COMPLETE THIS FORM WHEN DROPPING OFF ANY CORRESPONDENCE AND/OR PLANS TO THE HOWARD COUNTY DEPARTMENT OF INSPECTIONS, LICENSES AND PERMITS COUNTI

Date:	7/04/	ONLINE SUBMITTAL	PAPER SUBMITTAL
To:	Health Dept Dana Borne (Reviewer/Requestor's Name)	nd Health (Division)	<u></u>
From:	Jim Kerwin for Toll (Your Name Company Name)	Grothers	(Phone Number)
Subject:	Project name Kings words Project site address 10549 Permit # B2202469 Other information pertinent to this project	Pudding Lave SDP#	
✓ Please c	check the attachments below that you are submitted		
	etter of response to address plan review comment		
	evised plans and/or revised details: When submitt		dunlicate sets shall be submit
	etter Summarizing Changes nergy conservation calculations opies of revised Busenut flow Health Department Request		
	Health Department Request	DPZ/ DED Request	Applicant's Request
	wo sets of single-family model plans to be placed		
Ot	Other	-	
	Contact Person Information: (Required)

B22002469 10549 Pudding lare

Revised to remove Basement Bedroom and closet all flex space

BASEMENT FLOOR PLAN A-140 SCALE: 1/4"=1'-0"

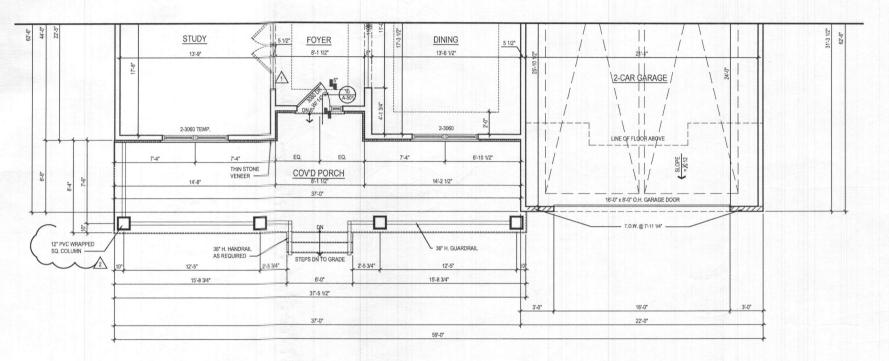
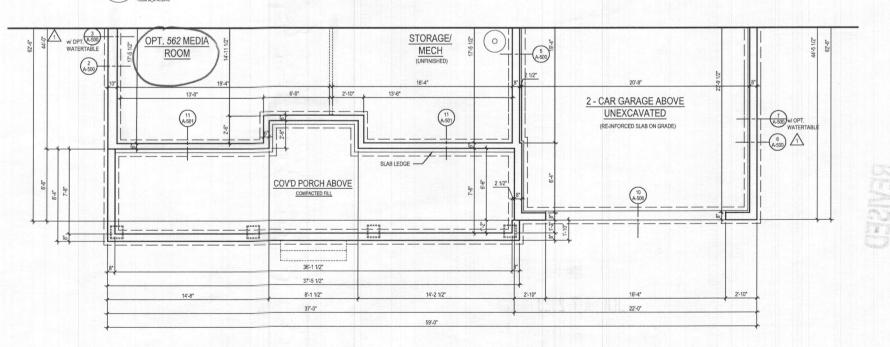
Health Dept

TOTAL Bedrooms = 5
